**RADIO SET PRC-F1**  
**'IN-PRODUCTION' CHANGE TO AGC CIRCUIT**  
**MODIFICATION INSTRUCTION**

**RECEIVER-TRANSMITTER RADIO RT-F1**  
**CIRCUIT CHANGE TO IMPROVE 10 KHZ PULSE GENERATOR OPERATION**  
**MODIFICATION INSTRUCTION**

**FIG 1 - IF AMPLIFIER, AGC CIRCUIT AND AM DETECTOR (PART OF 3CB1)**

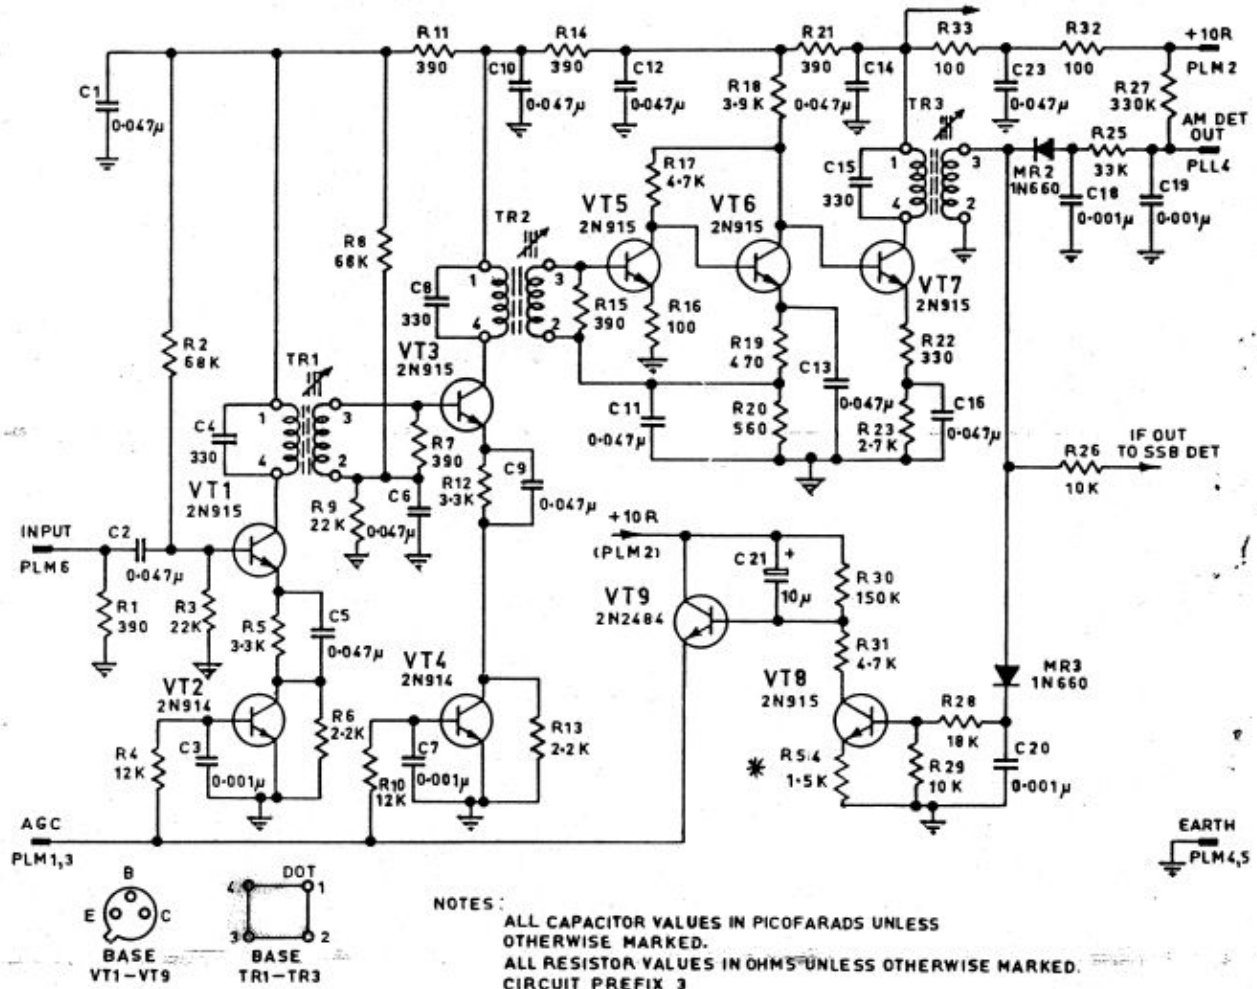
1. A 'production' modification, applicable to the receiver AGC circuit, has been incorporated in Radio Sets PRC-F1 from Serial No 350 onwards. The modification comprises the fitting of a 1.5 KΩ resistor (R54) in series with the emitter of AGC control transistor VT8 (Receiver IF, AGC, BFO Circuit Card 3CB1) to prevent low frequency flutter at certain levels of receiver input in the NCW mode.

\* Resistor R54 (1.5 KΩ) incorporated in PRC-F1 equipments - serials 350 onwards  
(TSU 141/67)

FIG 1 - CIRCUIT BOARD 9CB1 SHOWING POSITION OF RESISTOR R14 AND MODIFICATION RECORD NUMBERS (BEFORE MODIFICATION)

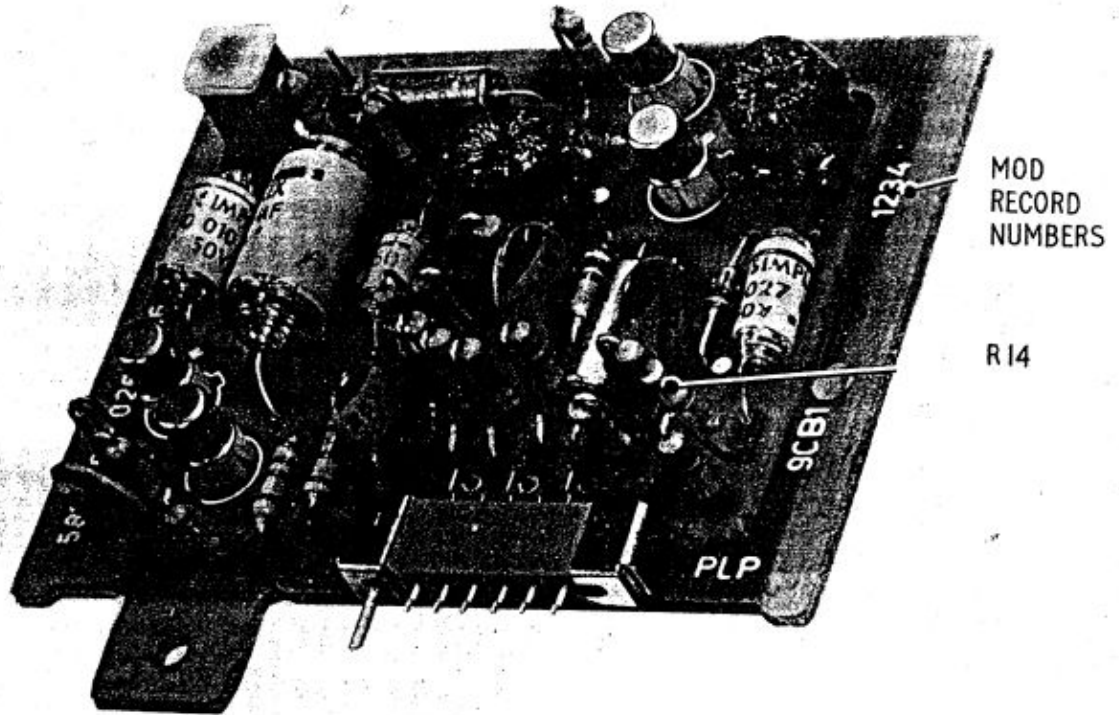
- c. Using the card extracting tool, withdraw Circuit Card 9CB1-10 KHz Pulse Generator (located on the extreme left of the assembly).
  - d. Identify resistor R14-39 K ohms (fig 1) and using a desoldering tool remove the 39 K ohms resistor.

12.
  - a. When resistor replacement is complete, carefully scrape away figure 1 stencilled on circuit board 9CB1 (fig 1).
  - b. On the front panel flange modification record plate, strike through figure 2 thus.

- e. Shape leads of the new 33 K ohms resistor and insert through the board holes, allow for approx 3/32 inch lead protrusion (under the board) on cutting. Bend pigtailed at approx 15° to the underside board surface; solder in position using a miniature iron. DO NOT OVERHEAT BOARD SURFACE AS FOIL DAMAGE MAY RESULT.

FIG 2 - 10 KHZ PULSE GENERATOR CIRCUIT 9CB1 (MODIFIED BY REPLACEMENT OF R 14).

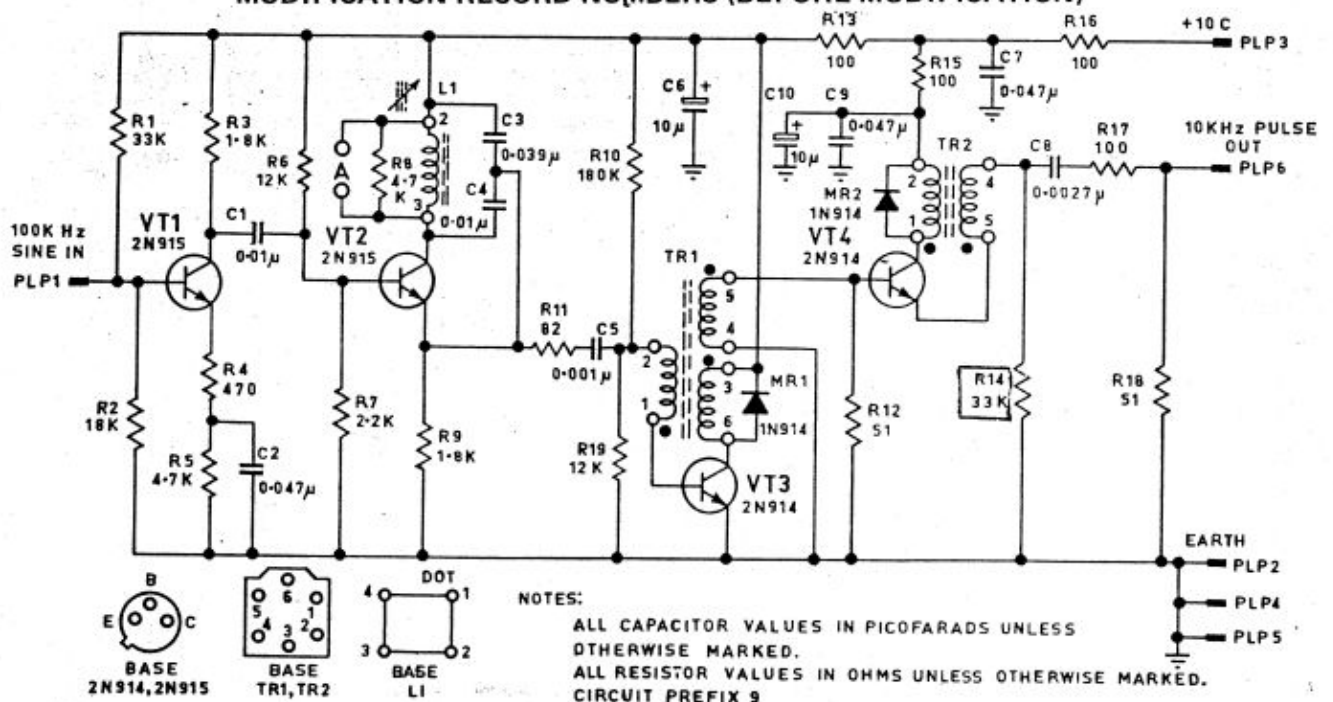
2. The odd 10 KHz malfunction is attributed to the delayed operation of the 10 KHz blocking oscillator VT4-9CB1. The main factors concerned are :
  - a. Resistor R14-9CB1 increases in value and alters the triggering point (emitter bias) of VT4-9CB1.

- b. Differences in pulse amplitude caused by the range of ferrite material used in the manufacture of transformer TR2-9CB1 alters the charge/discharge time of C8-9CB1 and the subsequent triggering point of VT4-9CB1.

3. In general, the output developed under these conditions produce a 6.666 KHz pulse which contains the 20 KHz spectrum but is devoid of 10 KHz points, hence the non-operation of the equipment at the odd 10 KHz frequency selector positions.

4. To compensate for variations in inductance of TR2-9CB1 and provide a suitable triggering time for VT4-9CB1; resistor R14-9CB1 (39 K ohms in existing circuit) is to be replaced with 33 K ohms.
